**BEFORE AN INDEPENDENT HEARINGS PANEL
OF THE WAIKATO DISTRICT COUNCIL**

IN THE MATTER of the proposed Waikato
District Plan (Stage 1)
Hearing 25

**EVIDENCE OF TODD JAMES LANGWELL ON BEHALF OF HYNDS PIPE SYSTEMS
LIMITED AND THE HYNDS FOUNDATION IN OPPOSITION TO REZONING
REQUESTS**

TRAFFIC

Figure 1 – Routes to Pokeno Village and M'Way Ramps

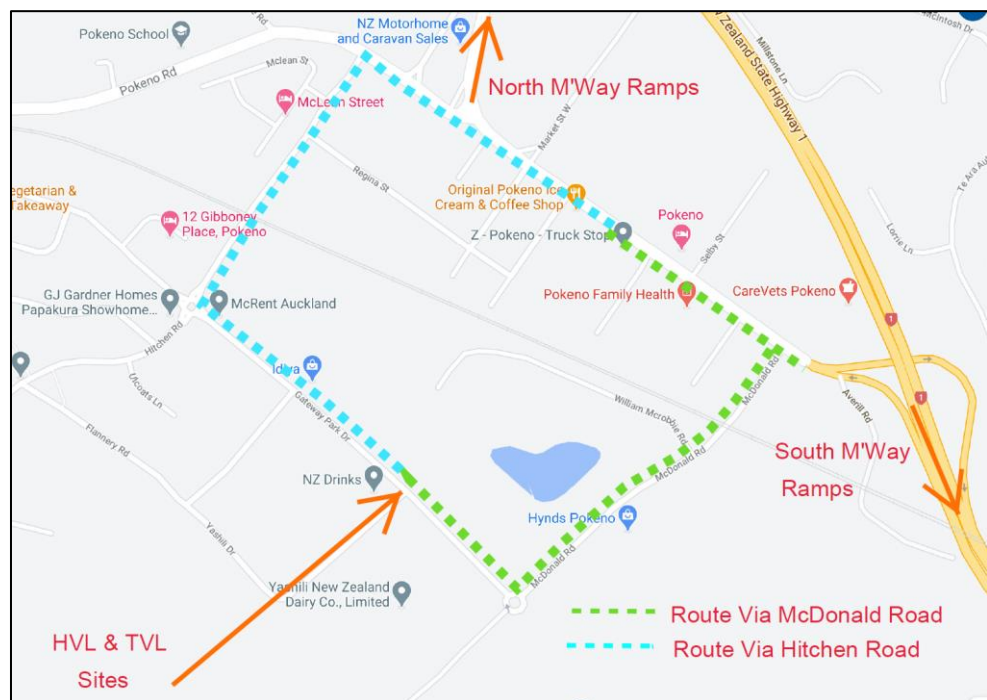
- 4.7** This will depend to some degree on whether the trip to the Village is the sole purpose of the trip, or whether they intend to travel to another destination. However, residents will become accustomed to using the most convenient route if others are congested and to avoid having to “double back”. For example, residents of HVL’s proposed development may choose to use McDonald Road to access the supermarket in the Village before heading north or as a return trip from the north, so they can avoid travelling back north again towards Pokeno Road and Hitchens Road.

- 4.8** Furthermore, Hitchens Road is anticipated to service several other residential areas and during peak times could be perceived to have a higher level of congestion compared to McDonald Road. This route involves a series of right turns to get to the Village, whereas the route via McDonald Road will have more left turns, which typically involves less delay.

- 4.10** Similarly, I anticipate Gateway Drive and McDonald Road will become the preferred route to and from the south for trips generated by other industrial activities on Gateway Drive and residential activities further north that want to avoid the delays at the right turn from Hitchens Road onto Pokeno Road and the right turn from Pokeno Road onto Great South Road (towards the Village), particularly during those peak times. Mr Hills appears to have not taken this into account in his assessment.

- 4.11** For these reasons, I consider there is a risk that McDonald Road may become more attractive to users than the 40% estimated by Mr Hills and could easily be used by greater than 50% of the trips generated from the HVL and TVL proposed rezoning, plus an additional 500 to 1,000 vpd from other land use activities on Gateway Drive and in the Hitchens Road area.
